**Preliminary/Final Water Quality Plan No. S-2816, T-Mobile at Gibson Property**

**Description**

115-foot tall unipole, wireless telecommunications facility and equipment compound, located on Parcel P161 at 2815 Cabin Creek Drive, Burtonsville, MD, RE-1 Zone, Fairland Area Master Plan and the Upper Paint Branch Special Protection Area (SPA)

Figure 1. Applicant's Proposal Located within Environmental Buffer on Parcel P161

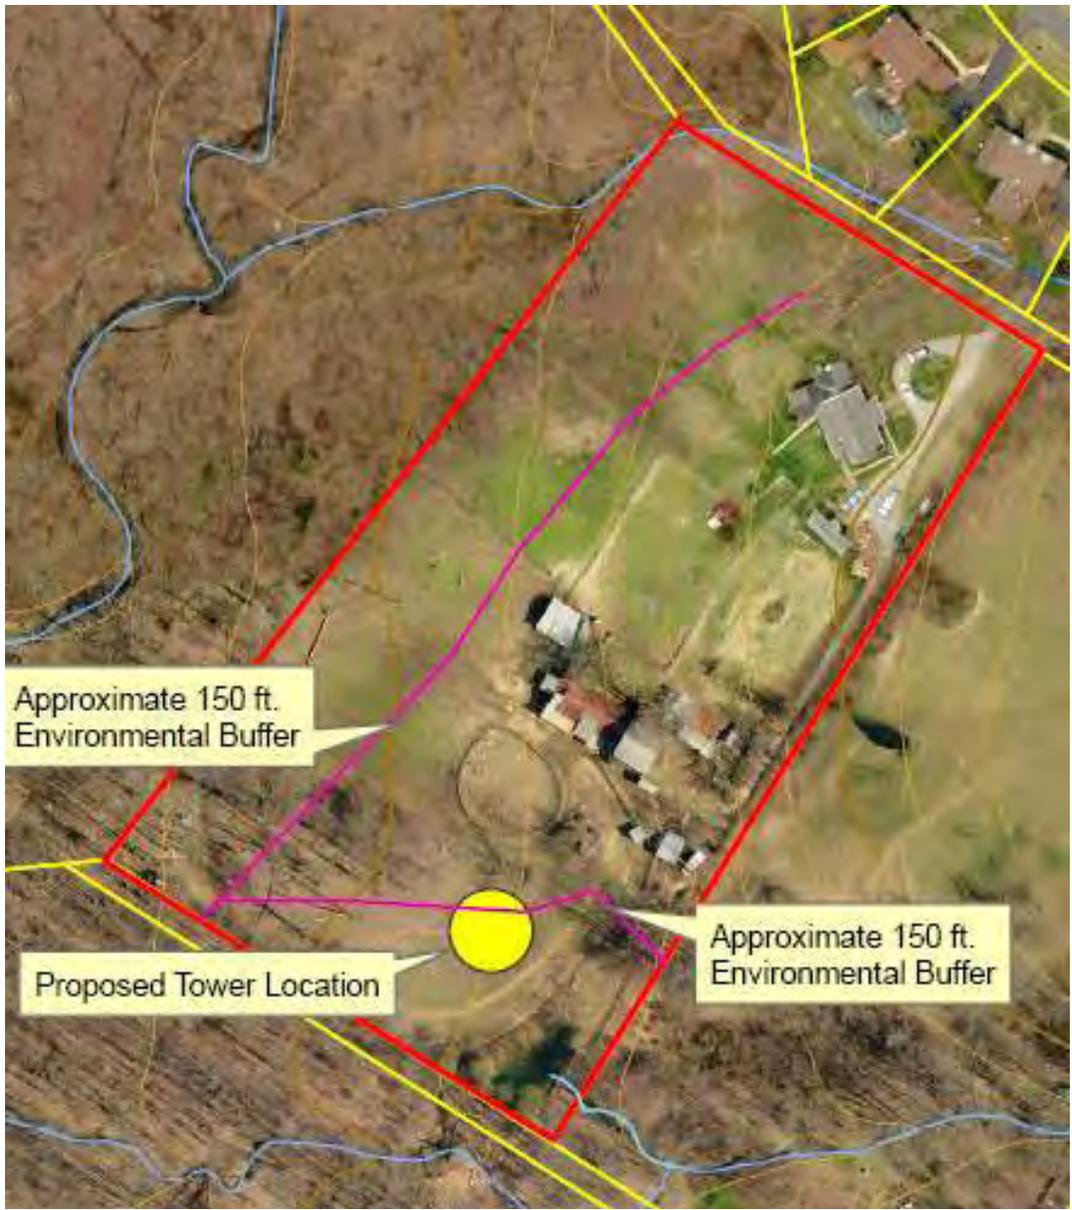
The proposed telecommunications tower will impact approximately 3,210 square feet of unforested environmental buffer. The access driveway and compound are proposed to be located approximately forty feet inside the environmental buffer. The impacts are the result of the construction of the gravel access road (a portion of which already exists within the buffer), the unipole and associated platform and equipment compound. From the applicant's perspective, this location was determined to be ideal in terms of minimizing visibility from Cabin Creek Drive as required per Section 59-G-2.58(4) of the Montgomery County Zoning Ordinance. The property is currently in use as a residence and is used for pasturing and training horses. The applicant's position is that the proposed location of the tower within the environmental buffer will minimize the impact on the existing use. The proposed location enables the property to continue its current use and utilize the existing training ring with minimal disruption to the horses. Access to the tower is off the existing gravel driveway that runs along the eastern property line. The gravel driveway will be extended westward to the location of the tower. The entrance gate to the compound will be five feet wide to prevent vehicle access that may result in compaction of the gravel.

Staff's recommended conditions of approval include the relocation of the proposed access driveway, cell tower, and entire compound outside of the environmental buffer. The access driveway and compound are currently proposed to be located approximately forty feet inside the environmental buffer. Relocating the proposed facility forty feet to the north would still allow the applicants to meet their objectives and requirements for the proposed cell tower use and maintain the current use of the property for pasturing and training horses. Staff finds that the requirements for environmental buffer protection within the SPA can only be satisfied by compliance with this recommendation.

1. Limit the impervious surfaces within the SPA to no more than eight percent as shown on the *Impervious Surface Plan Portion of the SPA Water Quality Plan*.
2. Submit revised plans to relocate the proposed access driveway, cell tower, and entire compound outside of the environmental buffer.
3. Conform to the conditions as stated in Montgomery County Department of Permitting Services (DPS) Water Quality Plan approval letter dated April 12, 2011 (Attachment 1).
4. Remove the gravel and concrete areas of the compound, including the access driveway and stabilize the area if the unipole is removed.
